SUBJECT: Vandalia Municipal  
Vandalia, Illinois  
Fayette County  
Illinois Project Number: VLA-4737  
SBG Project Number: 3-17-SBGP-120/133/139  
Contract No. VA021  
Item No. 05A, April 24, 2020 Letting  
Addendum A

## NOTICE TO PROSPECTIVE BIDDERS

Reason for Addendum:  
Plan Clarification

**REHABILITATION OF AIRPORT ENTRANCE ROAD AND PARKING LOT**

**TYPICAL SECTIONS AND DETAILS**

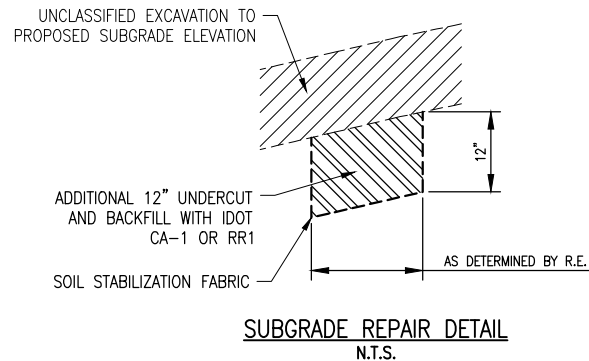
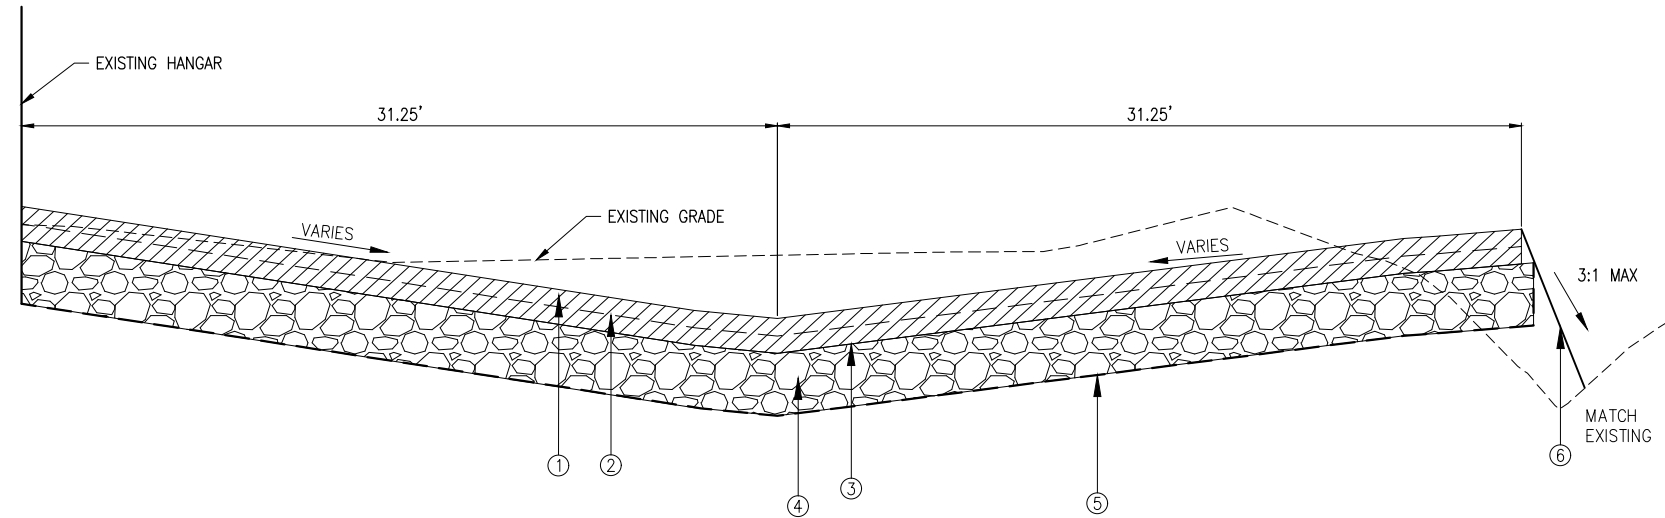
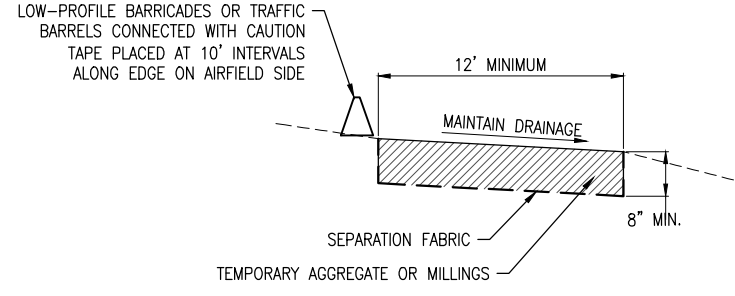
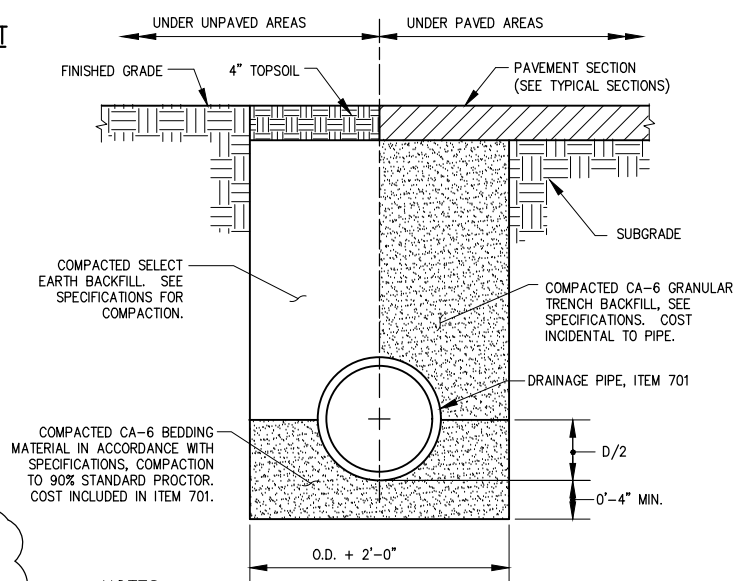
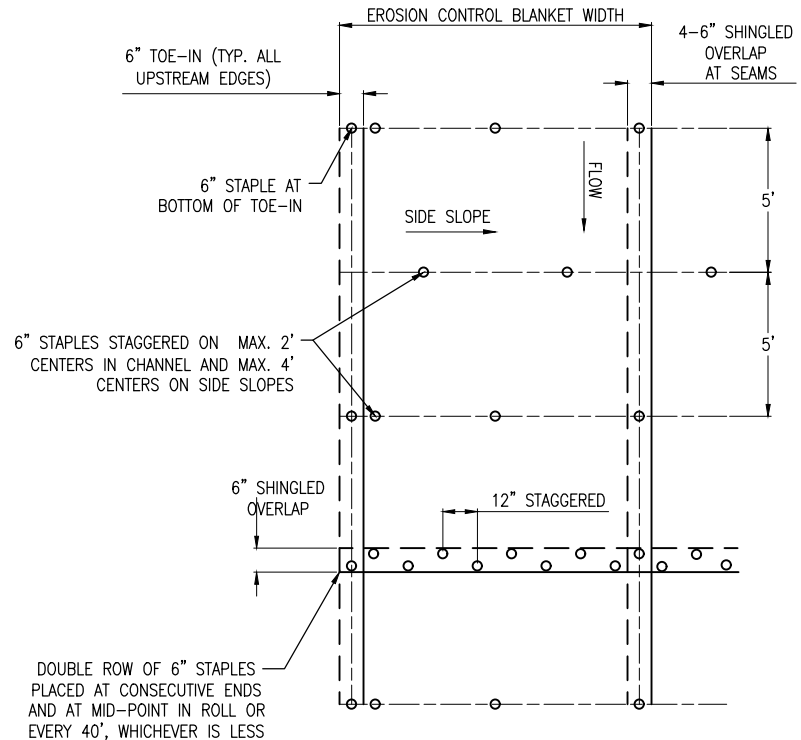
To All Plan Holders:  
Clarify discrepancy between Plans and Special Provisions regarding HMA mix design.

Plan Changes:  
Revise Sheet 6

- THE UNIT WEIGHT USED TO CALCULATE ALL HMA SURFACE QUANTITIES IS 112 LBS/SQ YD/IN. (0.056 TONS/SQ YD/IN.)
- THE "AC TYPE" SHALL BE "PG 64-22".
- SECTION 406 OF THE "STANDARD SPECIFICATIONS FOR ROAD AND BRIDGE CONSTRUCTION," ADOPTED APRIL 1, 2016 SHALL GOVERN ALL MATERIAL REQUIREMENTS FOR THIS ITEM.

NO.	DATE	DESCRIPTION		
		DES	DWN	REV
1	4/7/20	MIX DES.	NOTES	
		KBS	KBS	MJD
